**SYDNEY CENTRAL CITY PLANNING PANEL
COUNCIL ASSESSMENT REPORT**

| DA Number | DA/314/2017/A |
| Proposed Development | Section 4.55(2) modification to approved mixed use tower concept, specifically changes to building envelope, landscaping and conditions of consent. |
| Street Address | 37 – 41 Oxford Street, EPPING NSW 2121 (Lot 2 DP 1205413) |

Figure 2. Front facade of previous building and front setback trees on the site as viewed from Oxford Street (since removed).

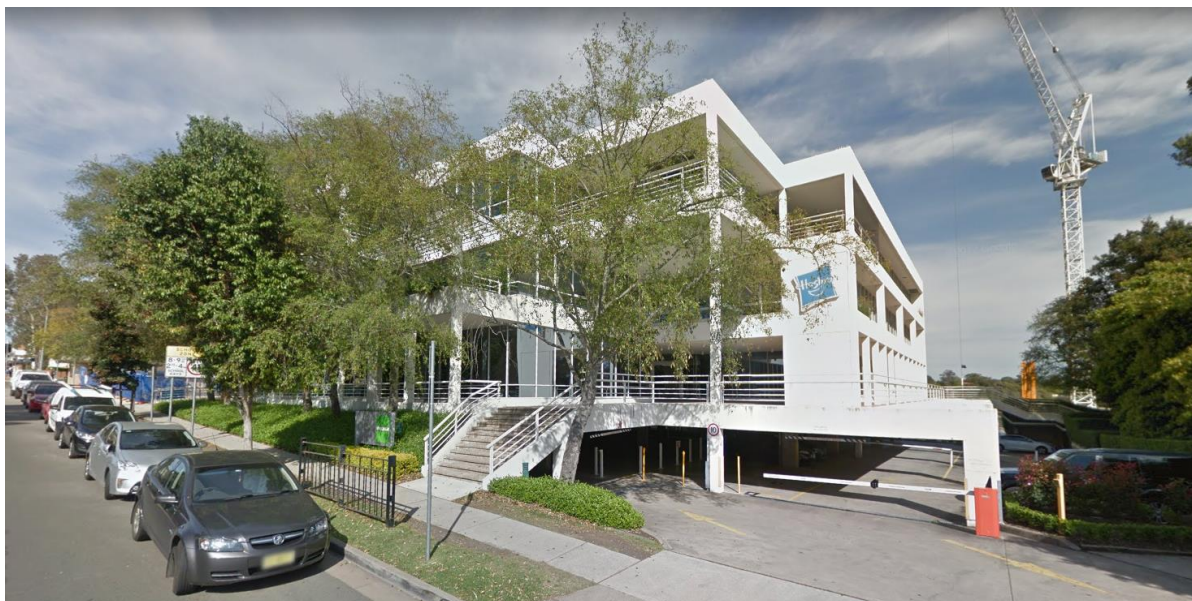
Further, as outlined in Figure 2 above, a row of trees previously existed in the front setback. Section 1B.7.1(h) of HDCP 2013 makes clear Council's expectation that removed trees should be replaced.

Figure 3. Proposed modified ground floor concept plan (dashed blue line represents previously approved envelope).

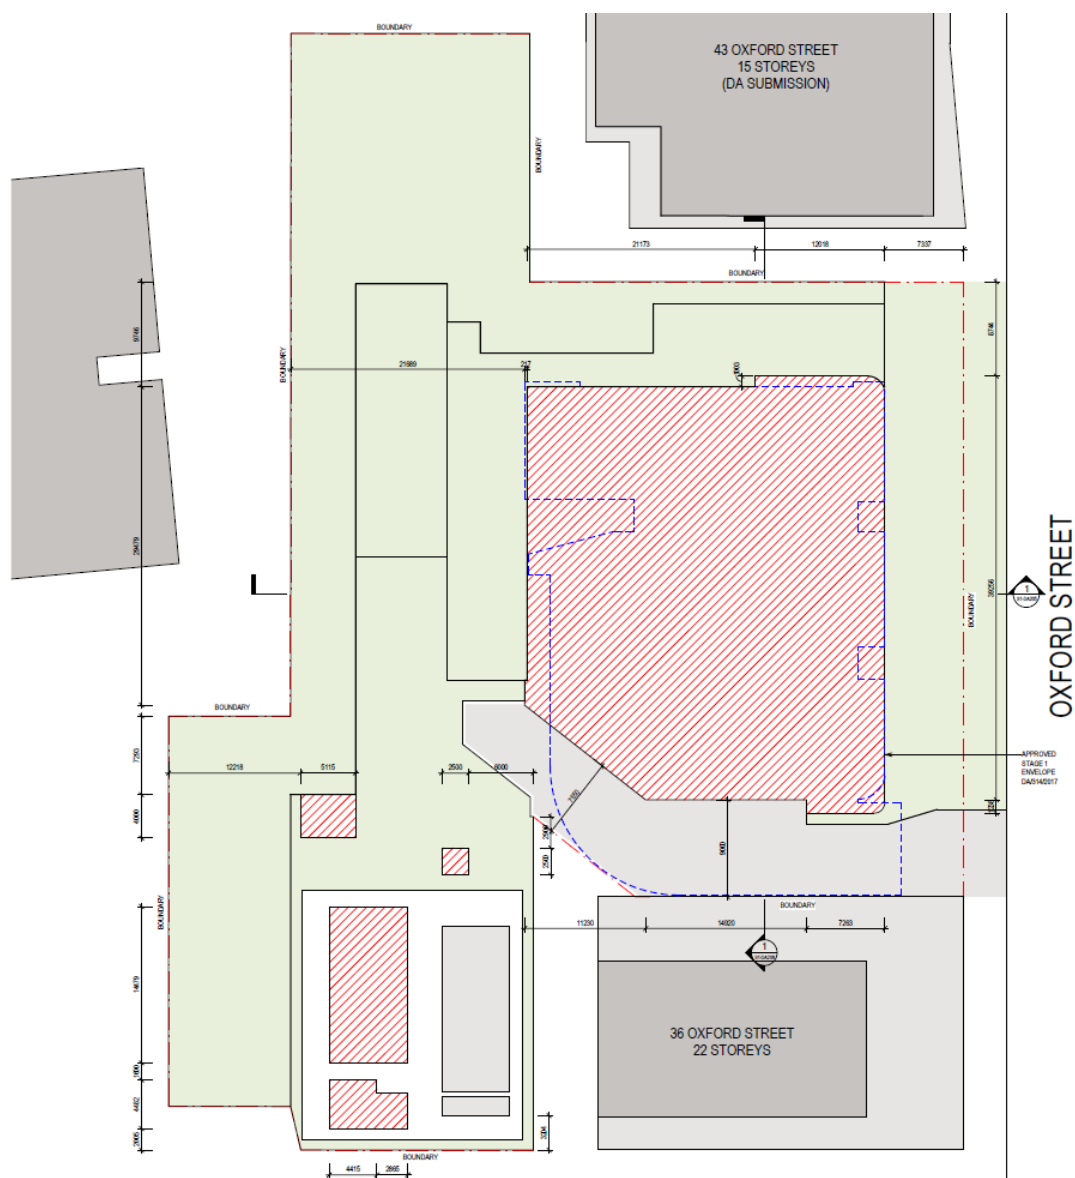
The proposal seeks to amend the podium footprint to allow space for a child care centre at ground floor level, and to increase the southern side setback and thus not provide a 'connection' to the podium of the adjoining site to the south.

The changes to the ground floor plan are minor (see Figure 3 above), do not reduce any setbacks, and as such are considered to be acceptable.

Figure 4. Approved concept plan front elevation (second floor connection highlighted in green).

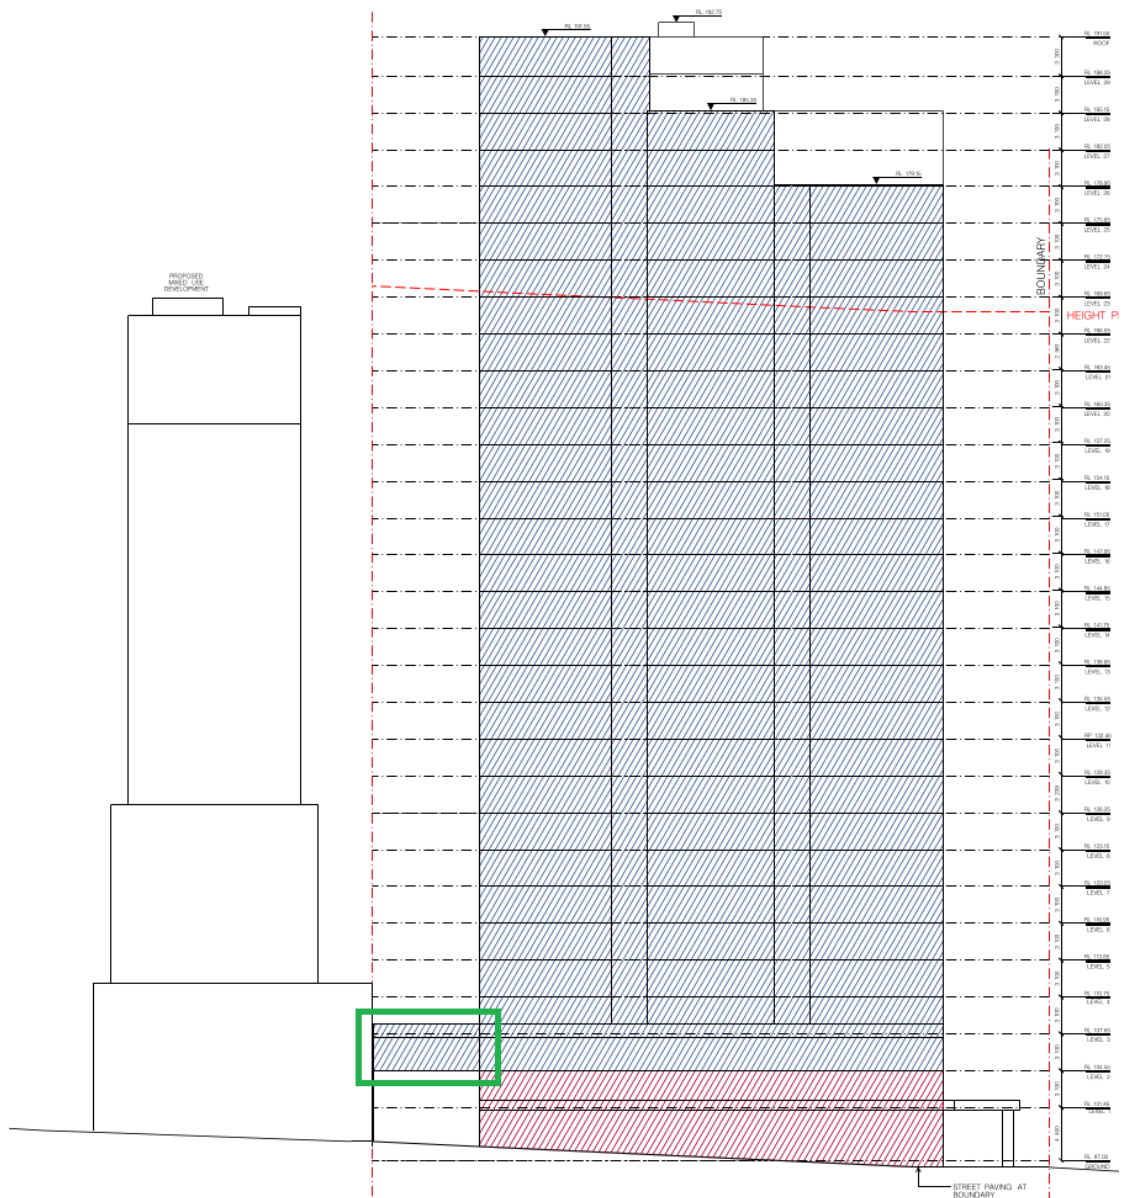
The concept included a second floor 'connection' to the adjoining site to the south, as outlined in the figure above.

The proposal seeks to delete this connection. The change to the southern side setback is not considered to be acceptable for the following reasons:

- The desired future character of the Epping Town Centre – East Precinct is to provide a street wall in the town centre which the proposal would not achieve.
- As outlined in the figure below, the adjoining building to the south includes a rear return which intrudes into the sightline down the southern side boundary of the subject site. This awkward relationship would be less perceptible were the connection in the concept implemented.

Figure 6. Extract from section drawing of proposed concept envelope (approved concept envelope in dashed blue line).

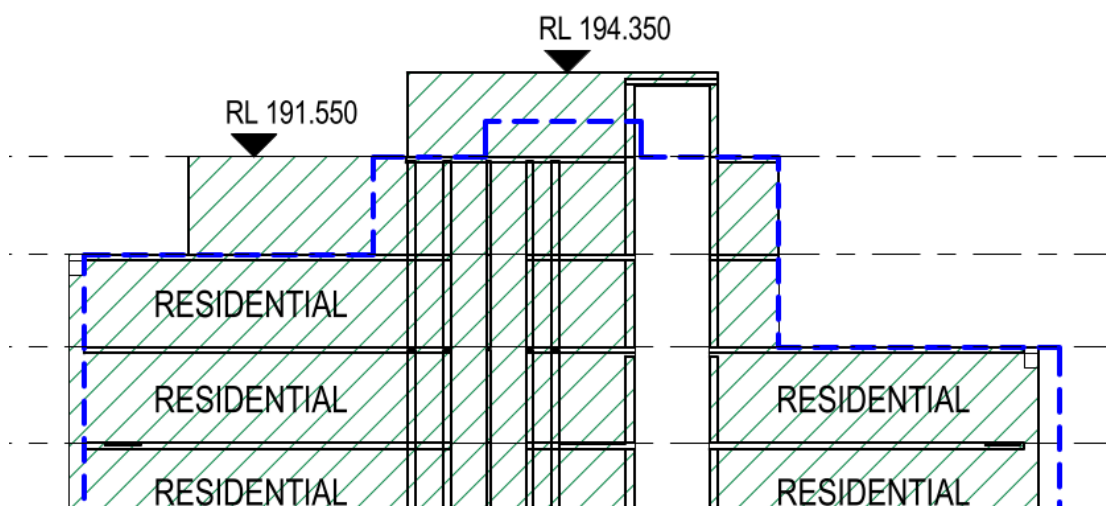
The proposal seeks to make amendments to the tower envelope to accommodate constructability, façade articulation and lift overrun / screening (see Figure 6 below).

The approved tower envelope, at a maximum of 95.35m, included a significant breach of the building height standard, 72m. The proposal includes a further breach, to a maximum of 96.95m, to accommodate the lift overrun, screening and constructability. A summary of relevant height figures is provided in the table below.

However, the additional height is not considered to be acceptable as the justification for the original height variation is eroded by the proposal. Specifically, the proposal to delete the ESD requirements and not provide replacement planting along the front setback undermines the environmental planning grounds for allowing the approved concept breach.

As such the revised tower envelope is not considered to be acceptable in the context of the other proposed deletions.
